ADDENDUM

Nelson Warehouse Item #13-1-A1

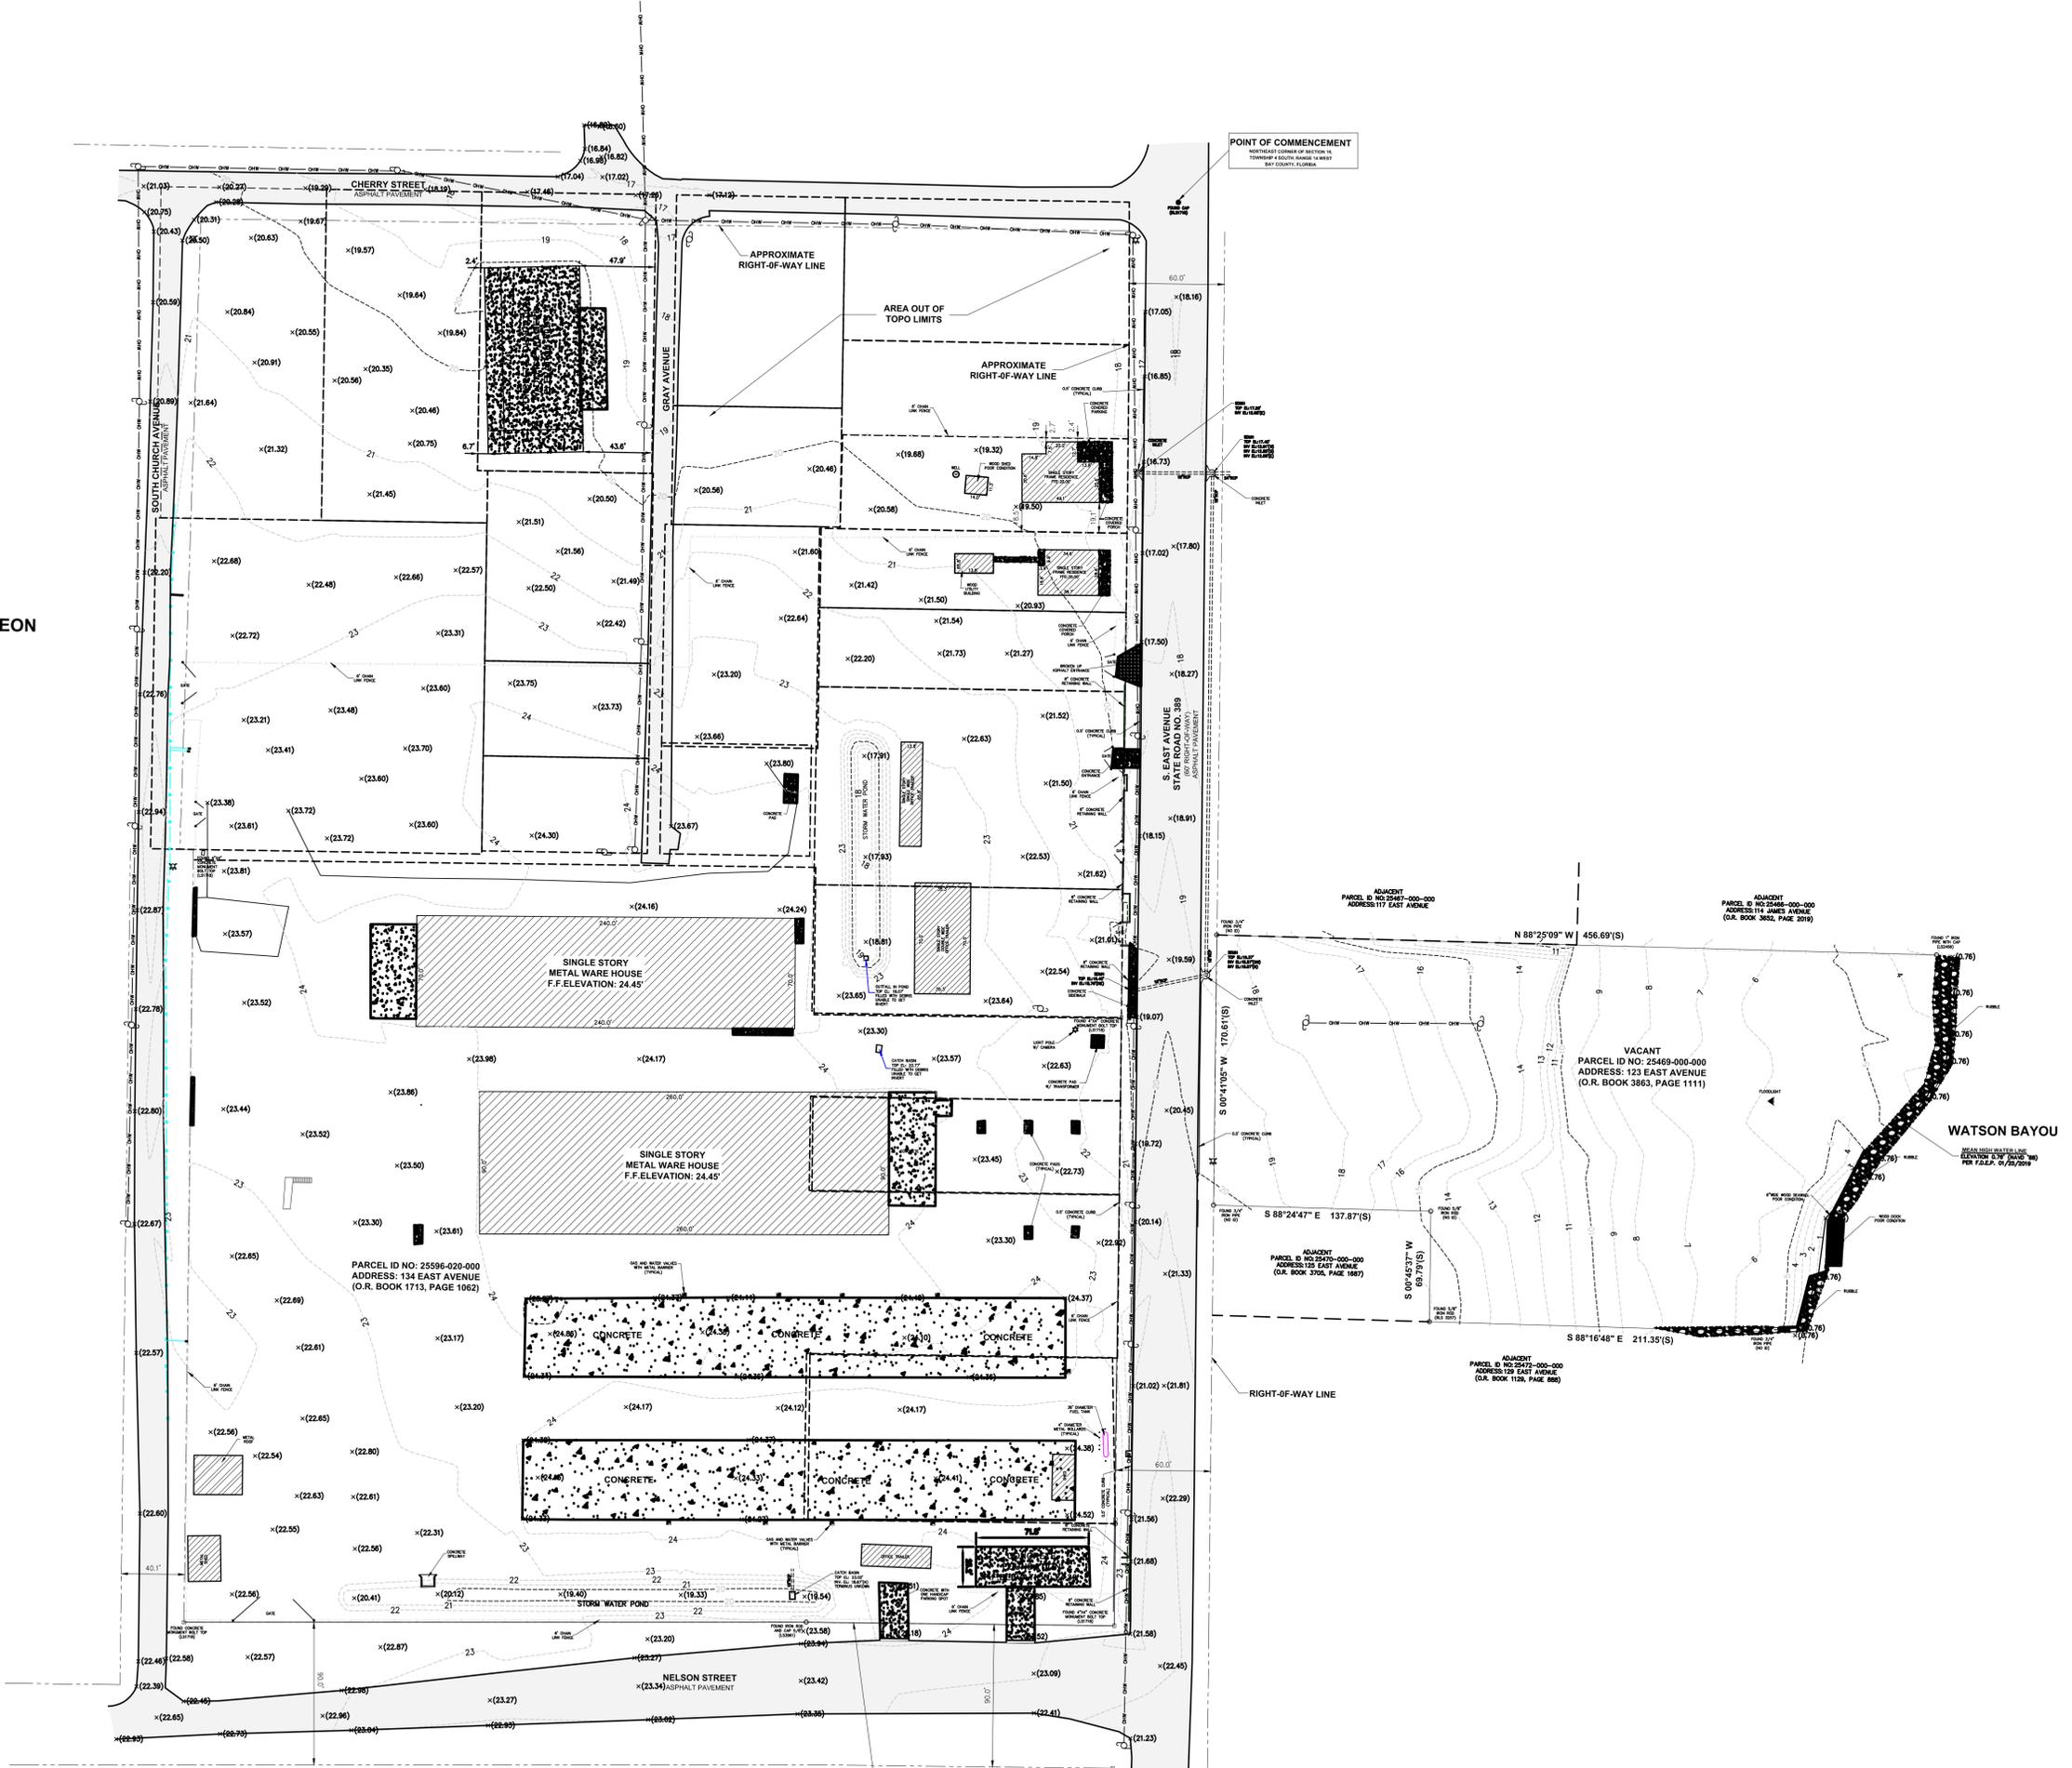
1. In the area that does not have a mezzanine we will need to have an angle iron grid installed in the concrete. The open floor area that measures 70' x 90' will need to have angle iron frame 3"x4"x1/4" cs. Angle at the slab perimeter and the same 3"x4"x1/4" CS angle every 4' running across the 70' section. This will be used to secure steel plate at a later date.
